RE: Revised Interim Remedial Measures Work Plan (October, 2000)
Mead Road Pond Area
Loeffel Site Environs

Re: Modification No. 1 – Mead Road Pond Backfill and Diversion Ditch Relocation
Interim Remedial Measures,
Mead Road Pond Area,
Loeffel Site Environs,
Nassau, New York
BBL Project #: 301.63.001

**Interim Remedial Measures
For the Mead Road Pond Area, Loeffel Site Environs
Nassau, New York**

Modification No. 1

COVER SYSTEM

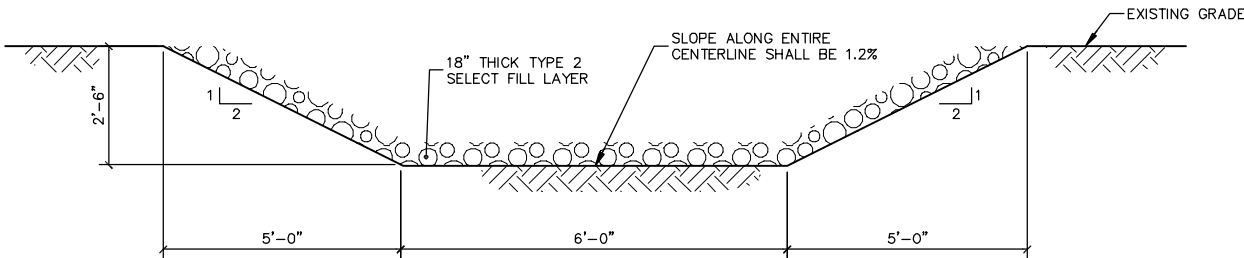
- COVER SYSTEM SHALL BE GRADED AT A UNIFORM SLOPE TOWARD THE NEW DIVERSION DITCH AND OUTLET.

Graphic Scale	No.	Date	Revisions	Init
NOT TO SCALE	1	9/12/01	DELETION OF GEOTEXTILE IN POND, CHANGES TO POND BACKFILL LIFTS	
NO ALTERATIONS PERMITTED HEREON EXCEPT AS PROVIDED UNDER SECTION 7209 SUBDIVISION 2 OF THE NEW YORK STATE EDUCATION LAW

- RESTORATION AT THE FORMER MEAD ROAD POND IS TO CONSIST OF IMPORTED CLEAN BACKFILL AND A 6-INCH-THICK LAYER OF TYPE 1 SELECT FILL TO FORM A UNIFORM SLOPING GRADE TOWARD THE NEW DIVERSION DITCH TO ELIMINATE FUTURE PONDING.

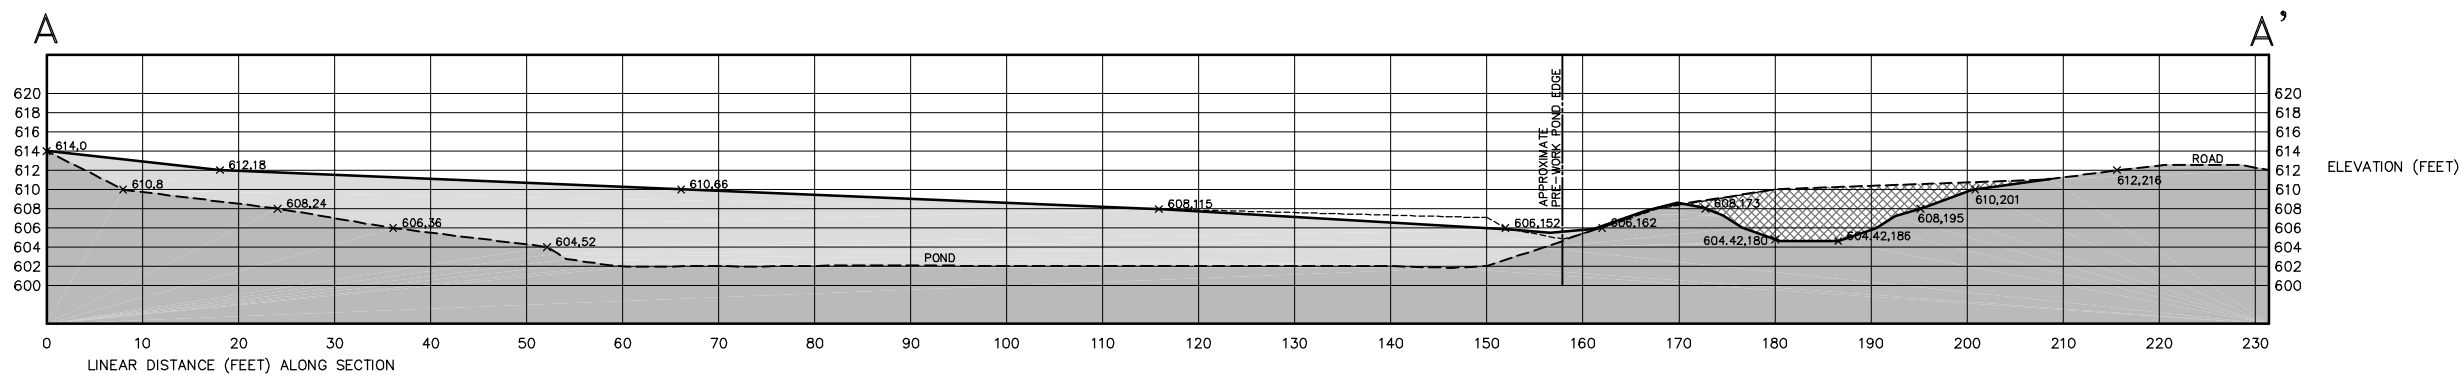
Figure MOD 1 presents three cross-sections for clarification of the above changes (prework, initial alignment, modified alignment).

The former Mead Road Pond inlet and tributary TIIA will be connected by construction of a permanent diversion ditch has been adjusted to result in a portion of natural soil being left in place between the former Mead Road Pond backfill material and the southern edge of the permanent diversion ditch. A layer of geotextile shall be installed at the former Mead Road Pond Inlet to the invert of the culvert under the road as shown on Technical Drawing 9A.
